Comments and suggestions:

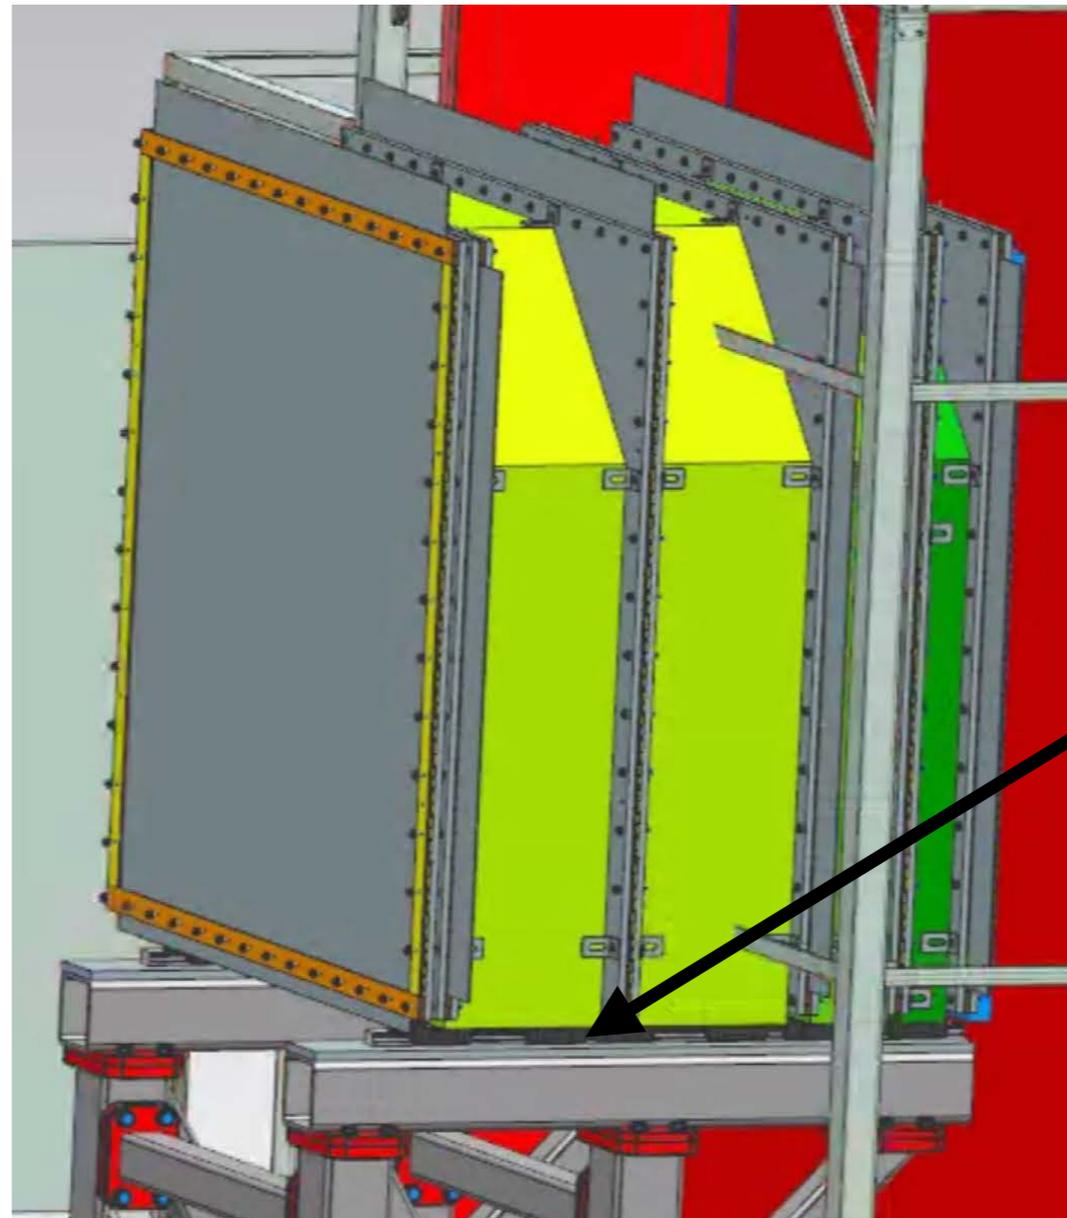
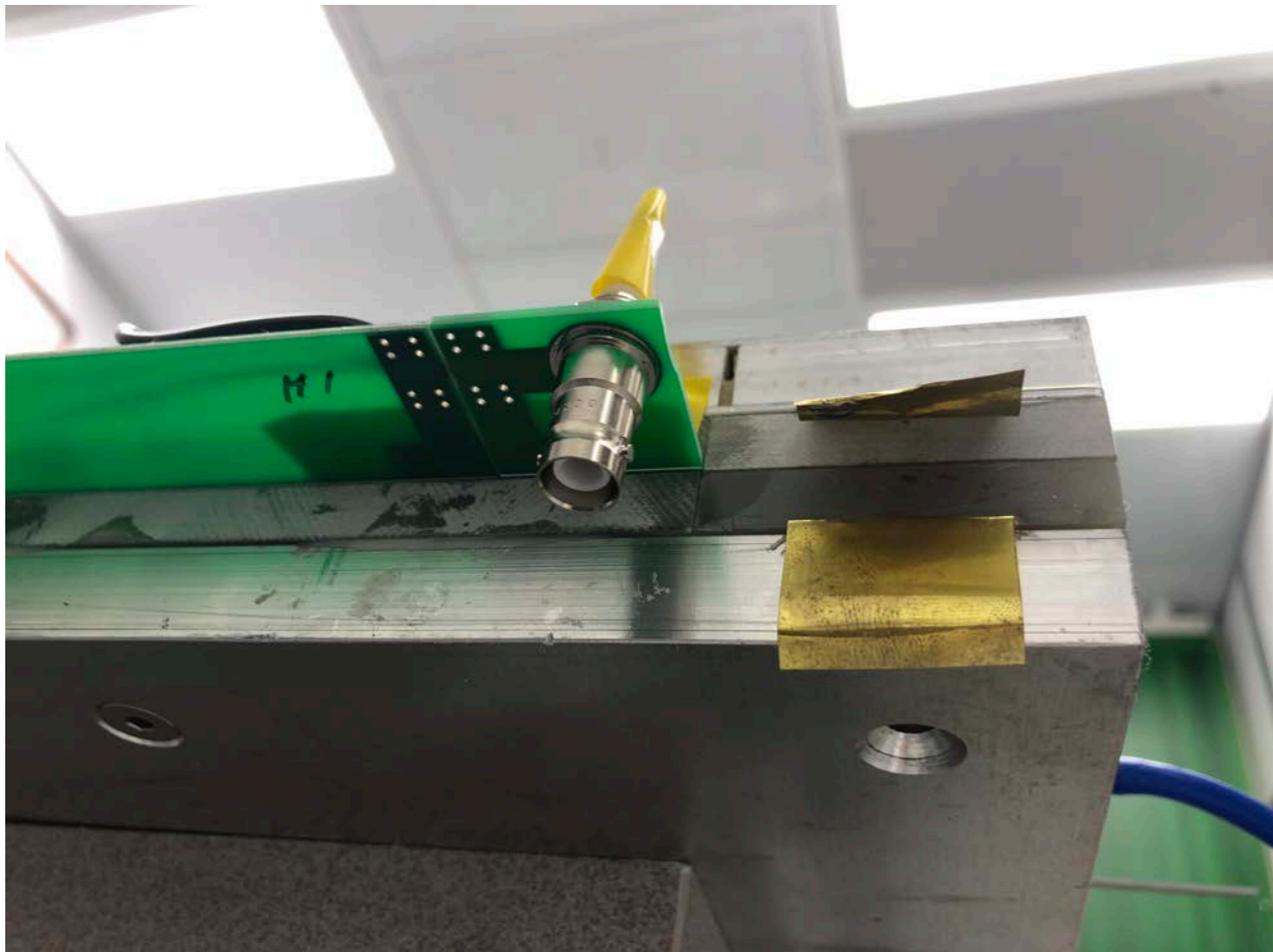
1. I assume on top and sides the absorber iron reaches to within 2" of the detector plate edge.
2. There's a clearance issue at the bottom when the preamp cards are in the "up" direction. The SHV cable is attached on the "down" HV side of the detector in the direction perpendicular to the chamber plane. We need clearance from the iron absorber to bring out the HV cable, and for attachment of grounding cables for the HV boards

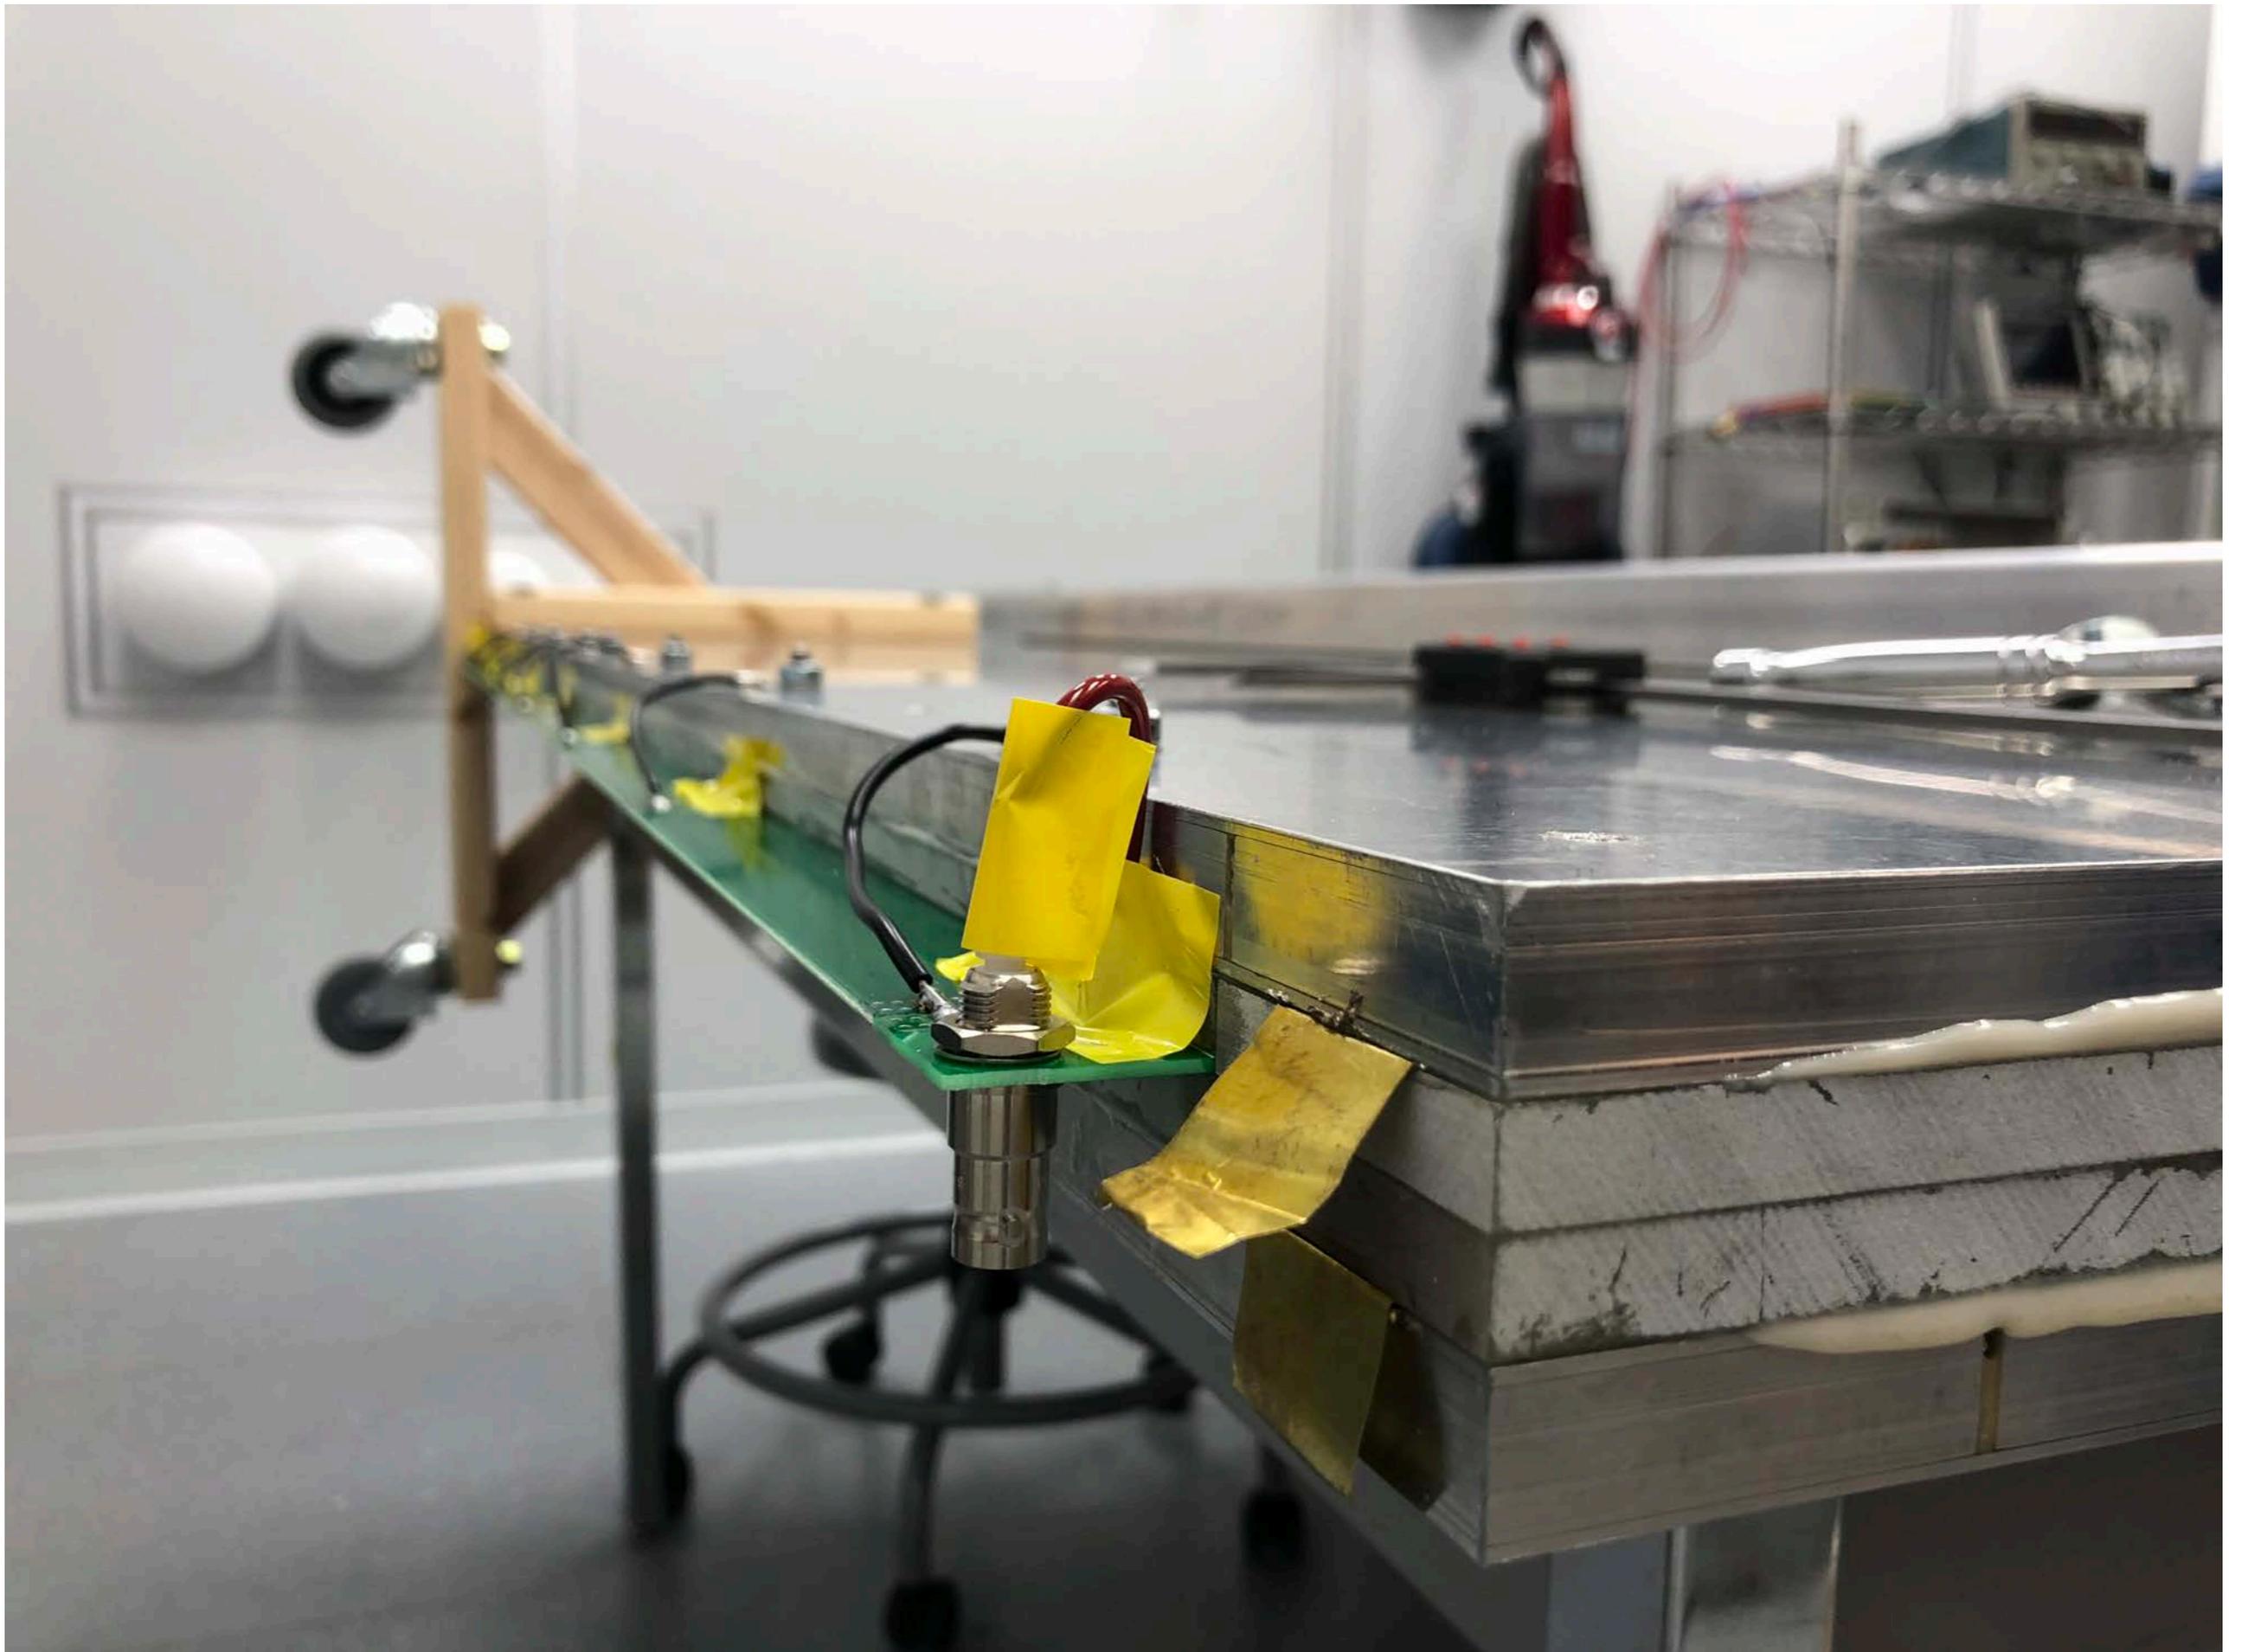
This is a problem area !

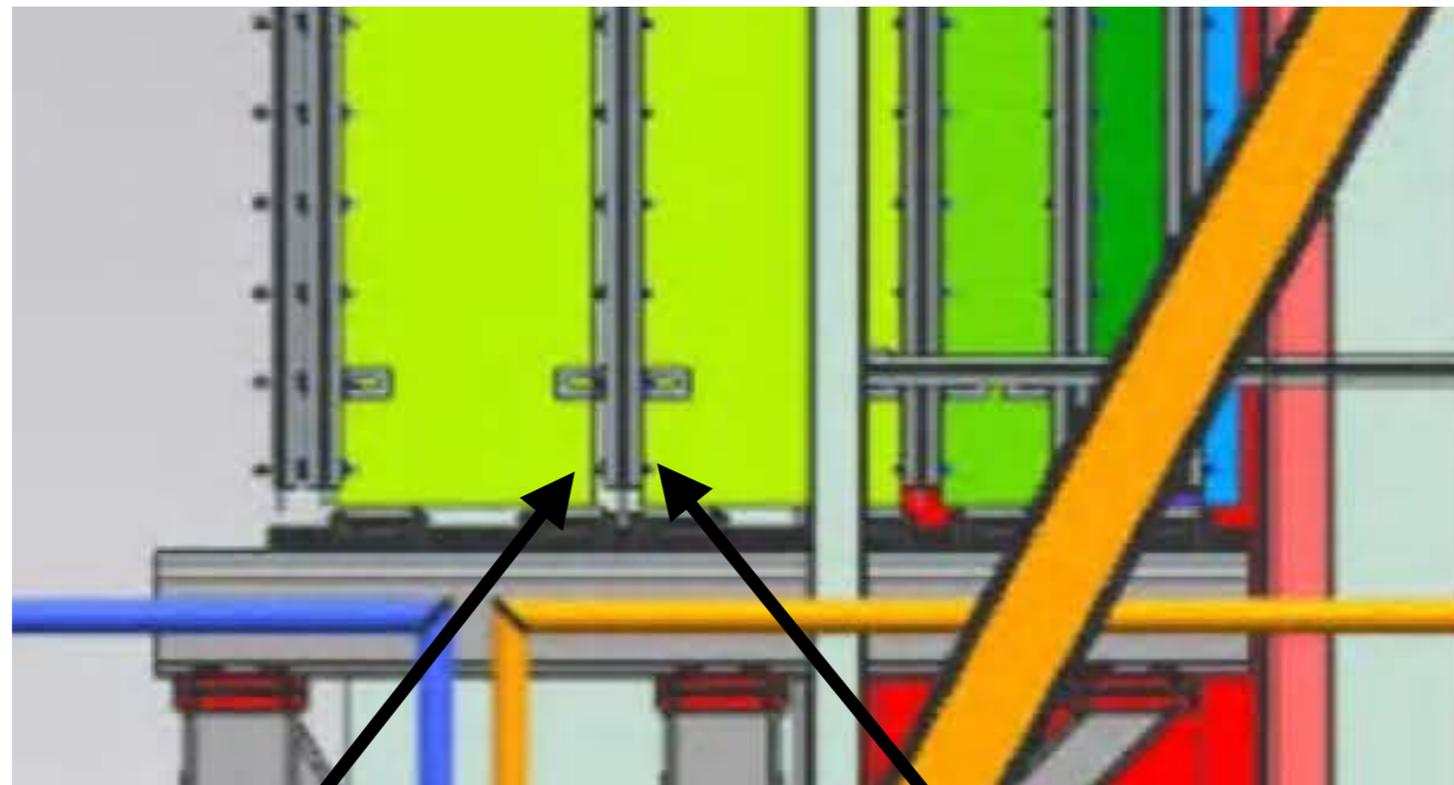
3. Is it possible to notch the iron plates at the bottom so there's clearance for the SHV cable, and for the grounding straps?

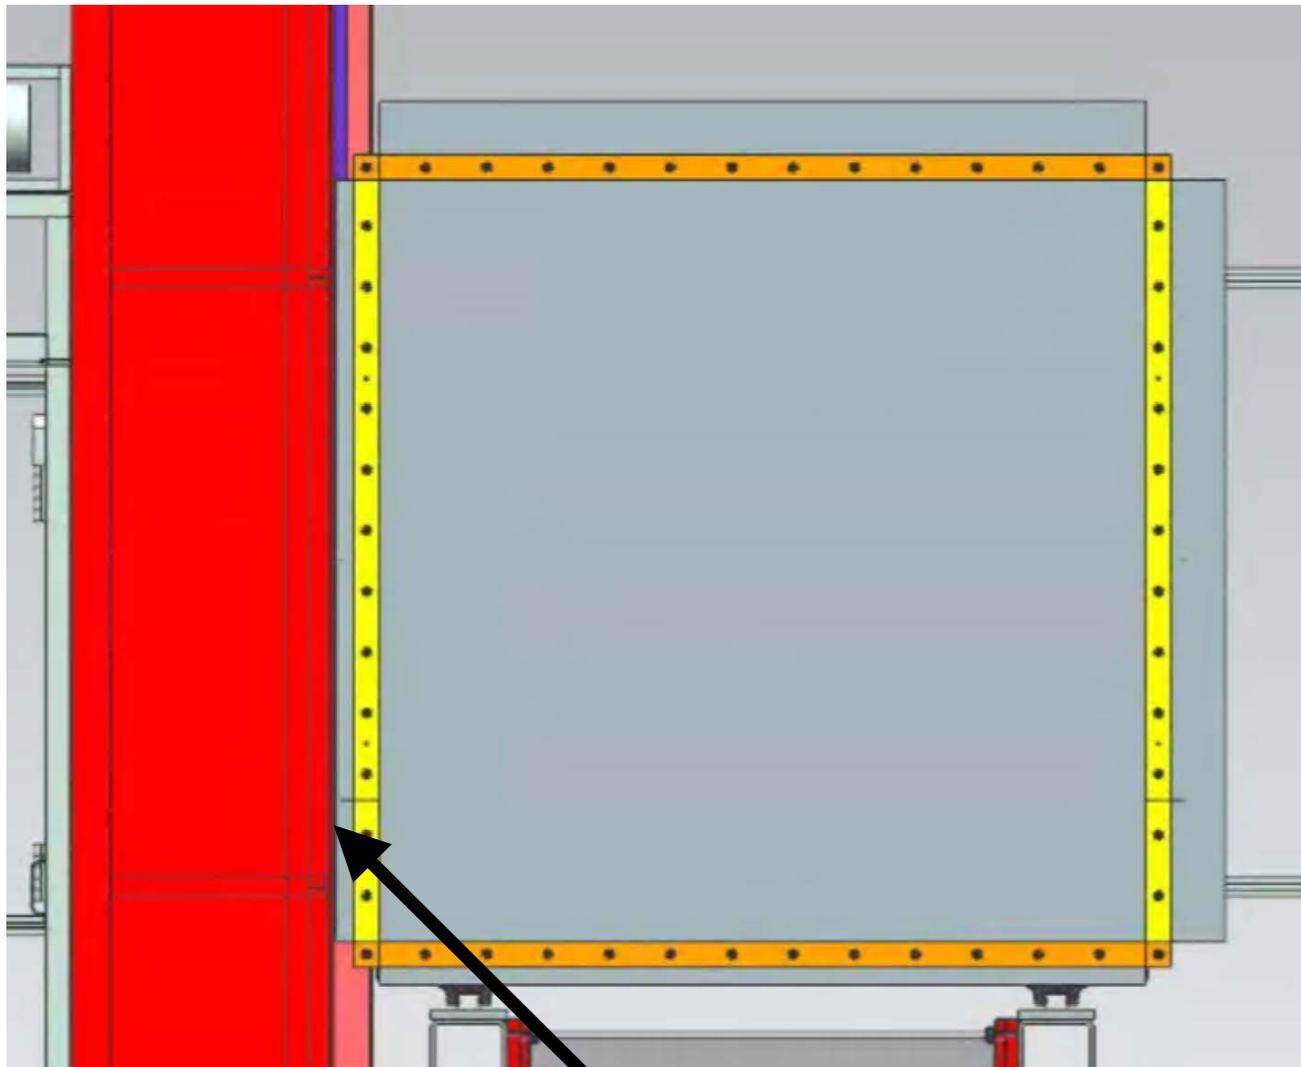
4. Clearance problem on the beam-right side of the detectors? When the preamp cards are in the "up" orientation, there are gas lines and fittings that come out on that side of the detector.
